International Aero Engines SERVICE BULLETIN

ENGINE - MAIN GEARBOX ASSEMBLY - PROVIDE A NEW VSCF
SHAFT PLUG ASSEMBLY

Jul.19/99

V2500-ENG-72-0355

Installation of VSCF shaft plug assy
Figure 1

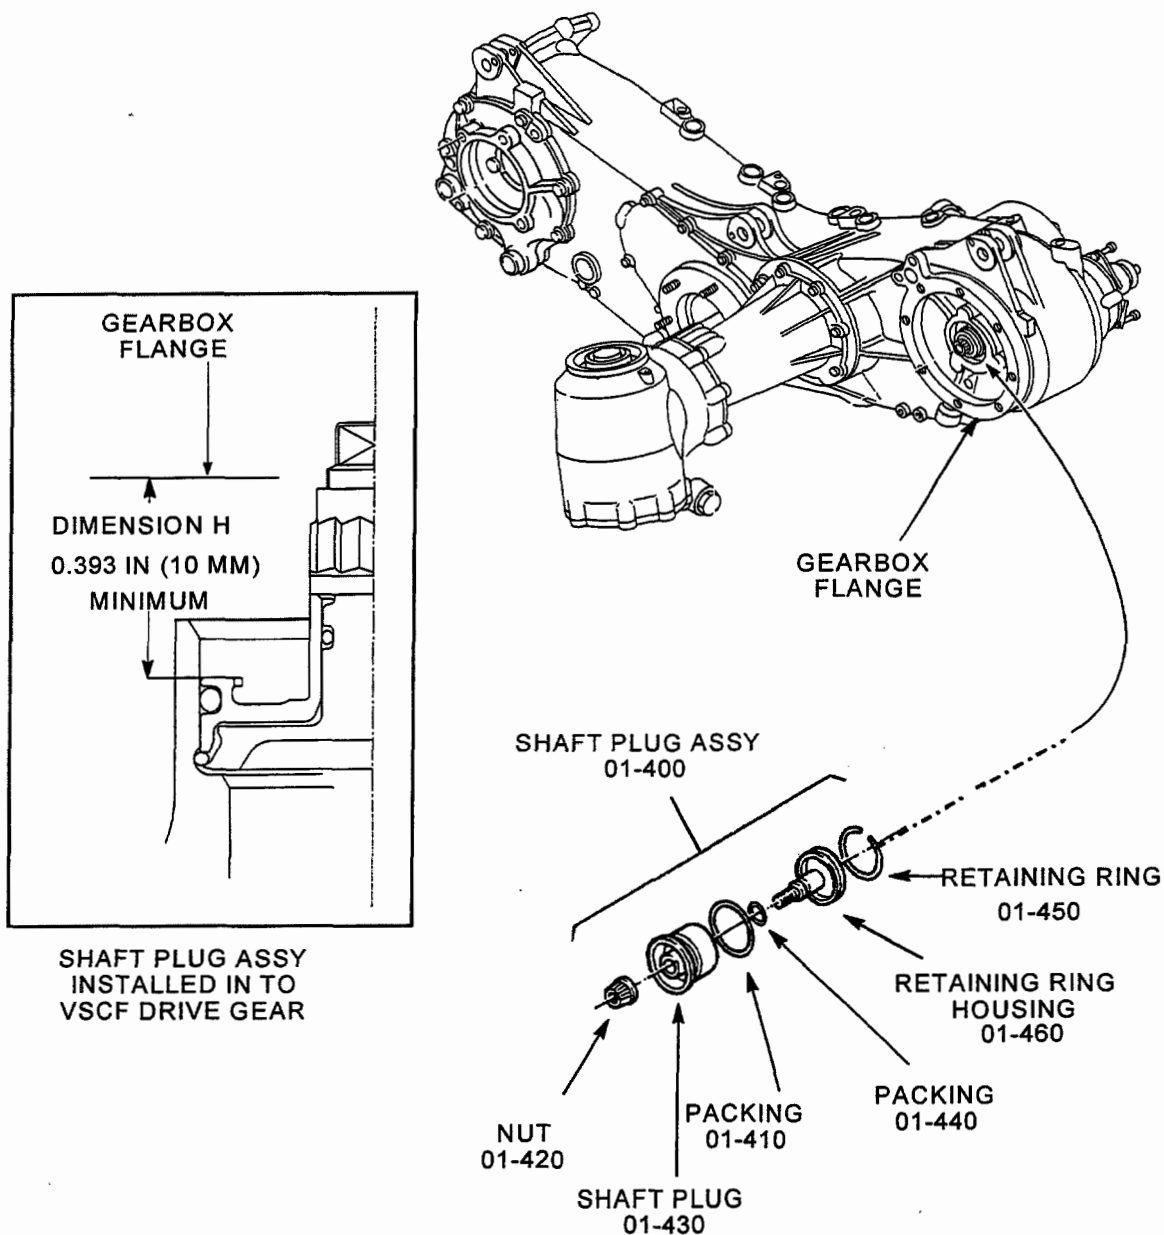
To introduce a revised plug assembly which eliminates the interference condition

- (1) Introduce a new plug assembly.
- (2) Create two new parts to reduce the axial dimension of the plug.

(3) Add in the gearbox assembly procedure, a dimensional check of the plug in order to assure the necessary gap for the bearing nut of the VSCF and avoid the interference.

(4) Add provision to facilitate the removal of the plug

- (1) Make sure that proper packings are installed on the retaining ring housing and on the shaft plug. See Figure 1.
- (2) Tighten the nut until the mating faces of the nut, shaft plug, retaining ring and retaining housing touch. Make sure that the retaining ring is evenly seated between the retaining ring housing and the shaft plug.

- (7) To avoid the interference between the VSCF bearing nut and the plug shaft check the dimension H between the shaft plug and the gearbox flange. The dimension H must be 0.393in. (10 mm) minimum. Refer to Figure 1. In addition, as alternative procedure, you can check the dimension between the shaft plug and the external flange of the QAD adaptor P/N 1B193-1. This dimension must be 0.730in. (18,5 mm) minimum.
